**MOORE PUBLIC SCHOOLS -  
MPS CHILD DEVELOPMENT CENTER**  
Moore Public Schools - Moore, Oklahoma  
AGP - Moore, Oklahoma

**CONSTRUCTION BULLETIN NO. 12**  
August 7, 2025

**A100**

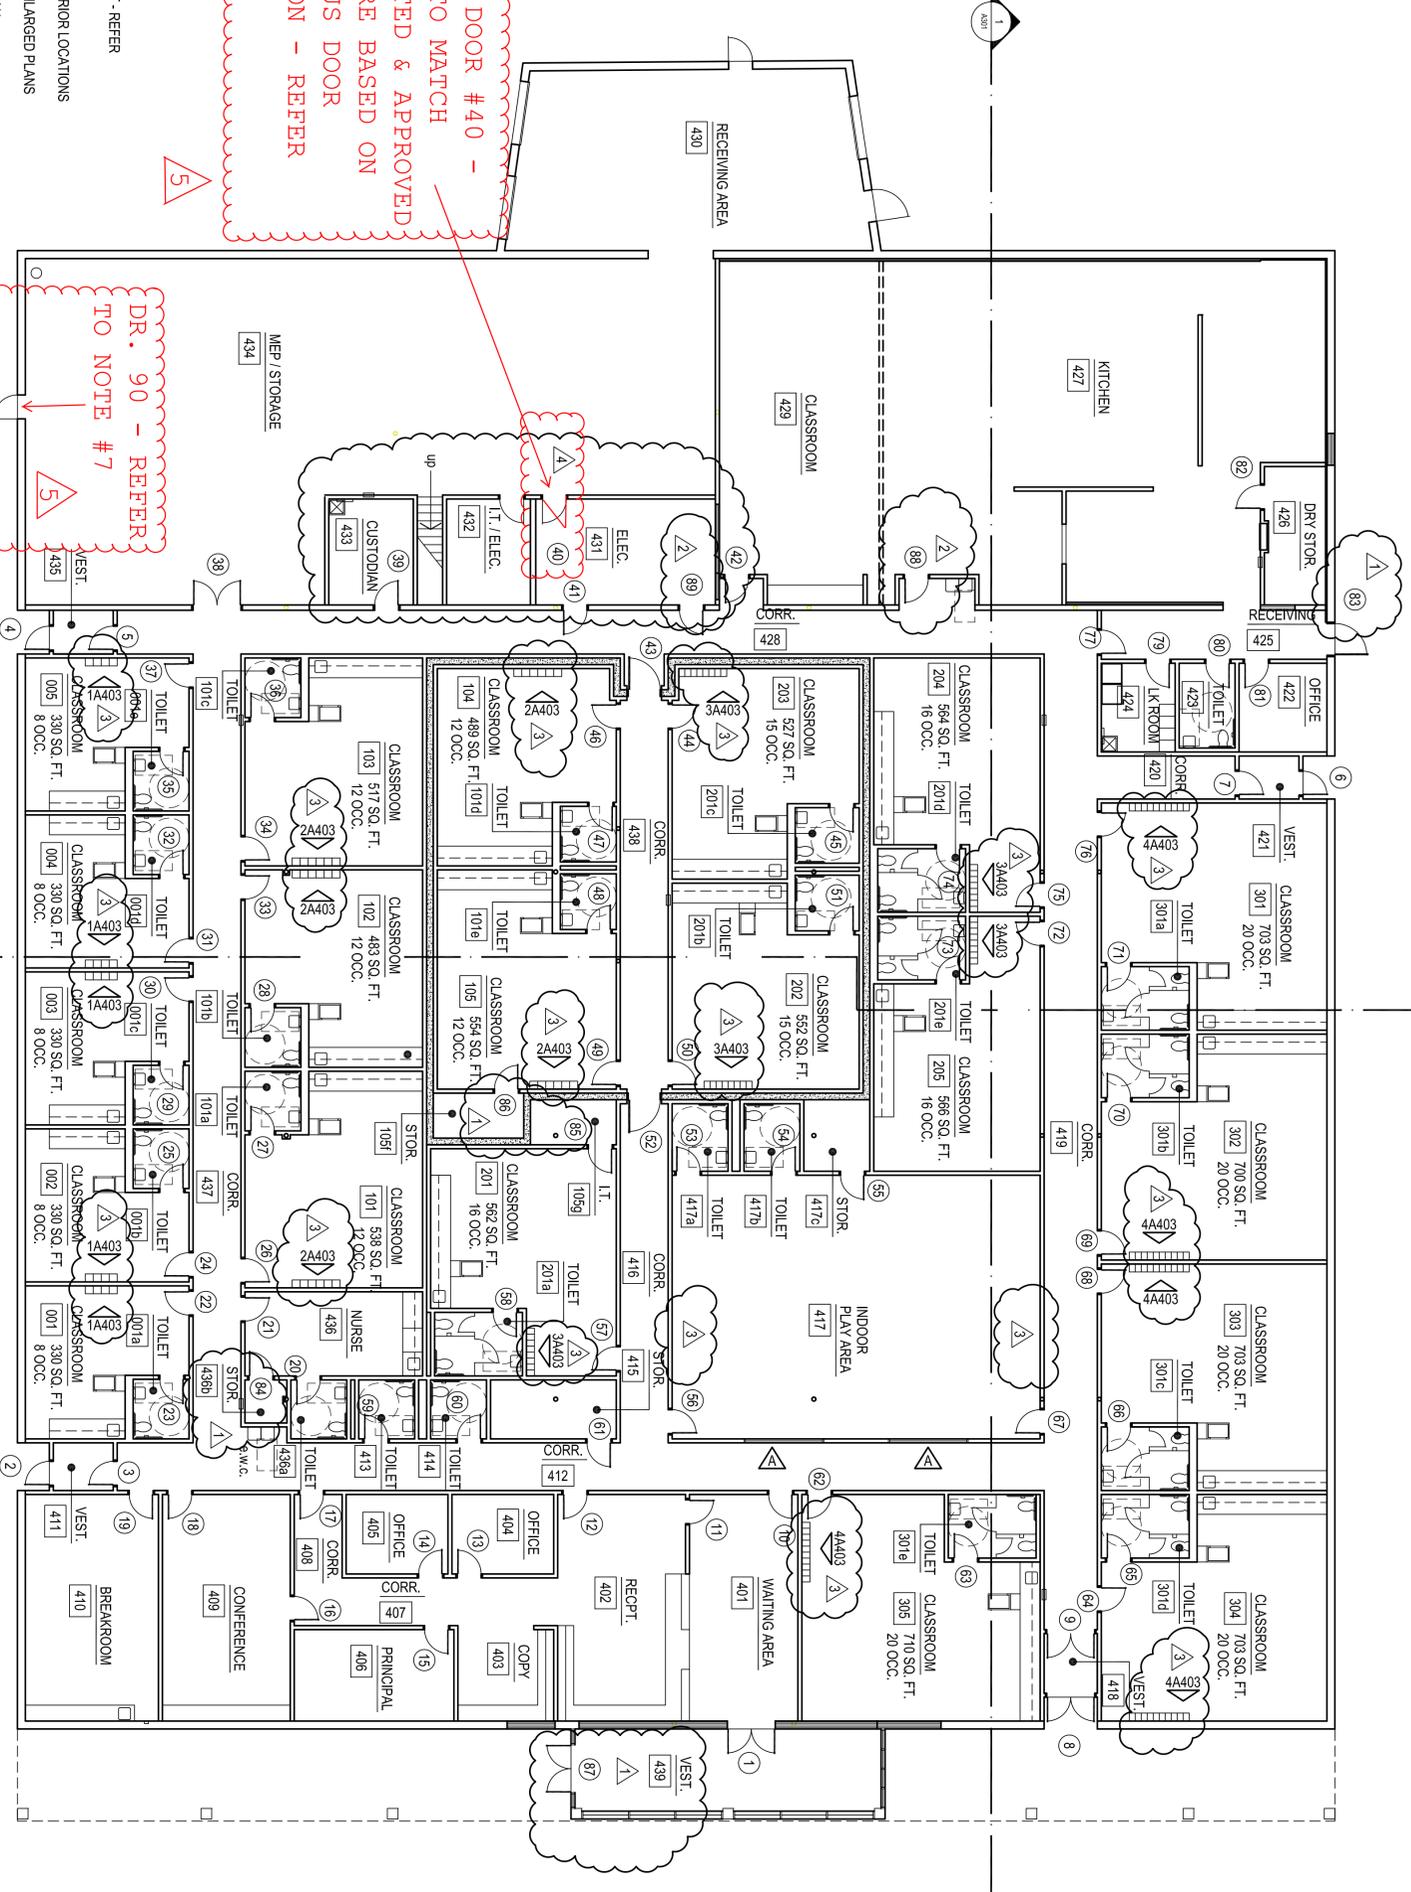
1. PROVIDE REPLACEMENT OF EXISTING HOLLOW METAL DOOR #90 WITH NEW HOLLOW METAL DOOR AND HARDWARE IN EXISTING HOLLOW METAL FRAME TO REMAIN AS PER ATTACHED DRAWING. PAINT DOOR AND FRAME TO MATCH OTHER EXTERIOR METALS APPROVED FOR THIS PROJECT.
2. PROVIDE DEADBOLT AND ARMOR FRONT TO EXISTING H.M. DOOR #91 AND FRAME TO REMAIN.

REVISE DOOR #40 -  
 SWING TO MATCH  
 SUBMITTED & APPROVED  
 HARDWARE BASED ON  
 PREVIOUS DOOR  
 LOCATION - REFER  
 CB-3

DR. 90 - REFER  
 TO NOTE #7

7. REMOVE EXISTING HOLLOW METAL DOOR & PREP / REPAIR / MODIFY EXISTING H.M. FRAME TO REMAIN TO RECEIVE NEW H.M. INSULATED DOOR & HARDWARE. DOOR ELEVATION TO BE "B" W/ HARDWARE SET NO. 5. REFER TO ATTACHED SHEET A601
